Allen-Bradley Data Highway II Asynchronous-Device Interface (Cat. No. 1779-KFL, -KFLR)

This document provides information on changes and corrections to the 1779-KFL, -KFLR, Series A, Revision E. The following pages contain:

Figure 4.4
Corrected Host-Board Switches

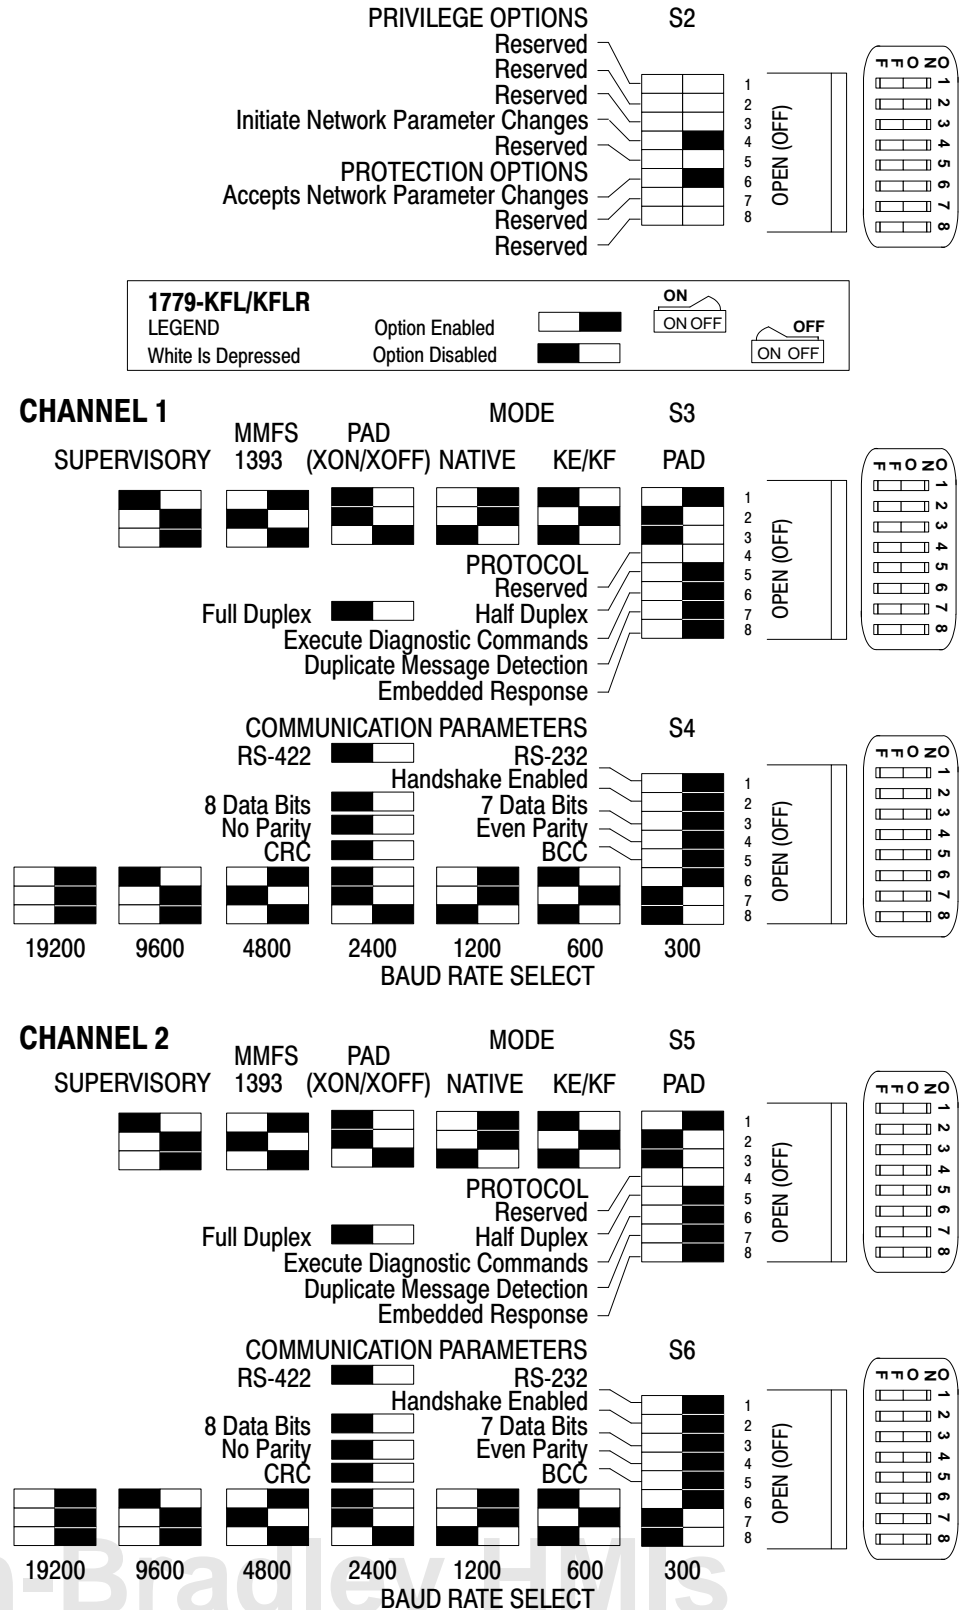
Replace: Figure 4.4 Host-Board Switches
with: The figure on the next page.

Figure 4.11
RS-422 DTE to RS-422 DTE (Handshaking Must Be Set to OFF)

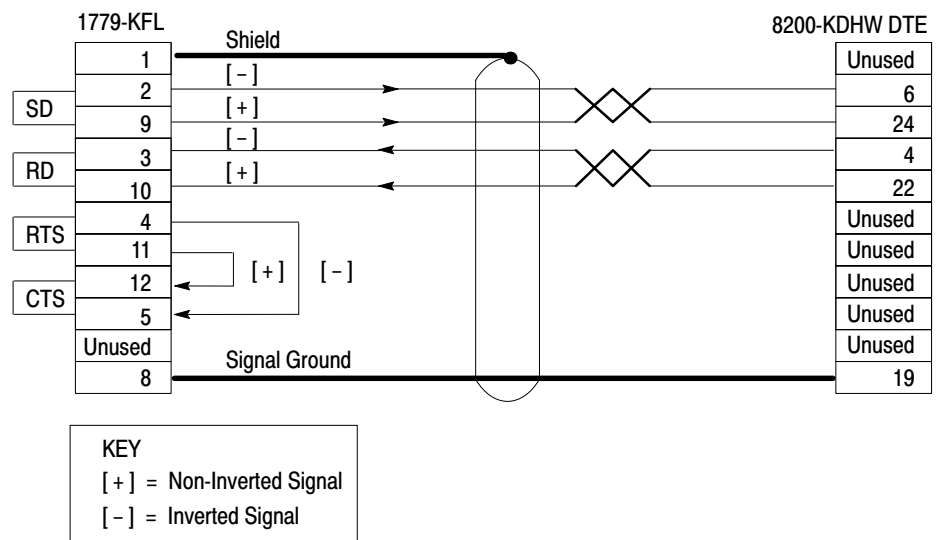
Replace: Figure 4.11 — RS-422 DTE to RS-422 DTE
with: The figure below:
